Re: ENERGY STAR® Specification for Set-top Boxes Version 4.1, Draft 2

On behalf of Entropic Communications, Inc., I am offering comments on the Environmental Protection Agency's Draft 2 ENERGY STAR® Specification for Set-top Boxes Version 4.1 released May 30, 2013.

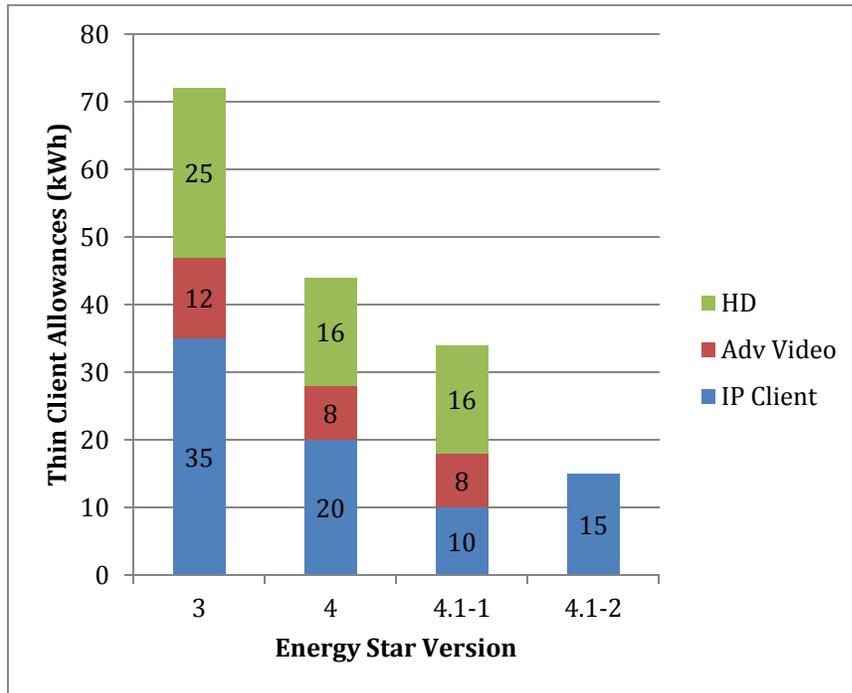
EPA has proposed to dramatically reduce Thin Client allowances to levels similar to “over the top” devices. The chart below shows the adopted and proposed AEC allowances for this product type from ENERGY STAR 3.0 to the latest 4.1 draft.

The latest proposed allowances do not properly account for Thin Client functional requirements. In the first place, EPA appears to have premised its analysis on the mistaken assumption that Thin Clients are functionally equivalent to over-the-top devices. In fact, over-the-top devices, such as Roku, typically operate with more compressed or lower resolution video. Service Providers require Thin Clients to operate at the highest rate of resolution (19-20 Mbps) and to have advanced applications processors capable of running complex video and graphics software stacks. Any Service Provider device also needs to support specific quality-of-service and diagnostic/manageability requirements, and contain conditional access level security features. The next generation Thin Client devices have multiple CPUs and operate at up to 5000 DMIPS of processing power to support modern and future Service Provider user interfaces and applications. To meet those performance requirements, both Service Provider IP set-top boxes and IP Thin Clients use equivalent silicon. This typically consists of a home networking / IP interface (like MoCA), an advanced video/graphics decoder engine and a high-speed applications processor. An IP Thin Client can talk to any/all of: a DVR, a gateway or the cloud. Client devices also typically include a broader variety of video outputs than HDMI or composite in order to handle the wide variety of TVs used by service providers' subscribers. Overly limiting the allowances for Thin Clients will actually create disincentives for whole home architectures.

To rectify these problems, MoCA and Thin Client allowances must be raised to match the performance required by Service Providers. Although there are many ways to raise the allowances to better match service provider IP set-tops, we recommend that the allowances (in kWh/yr) be set as shown in Table 2:
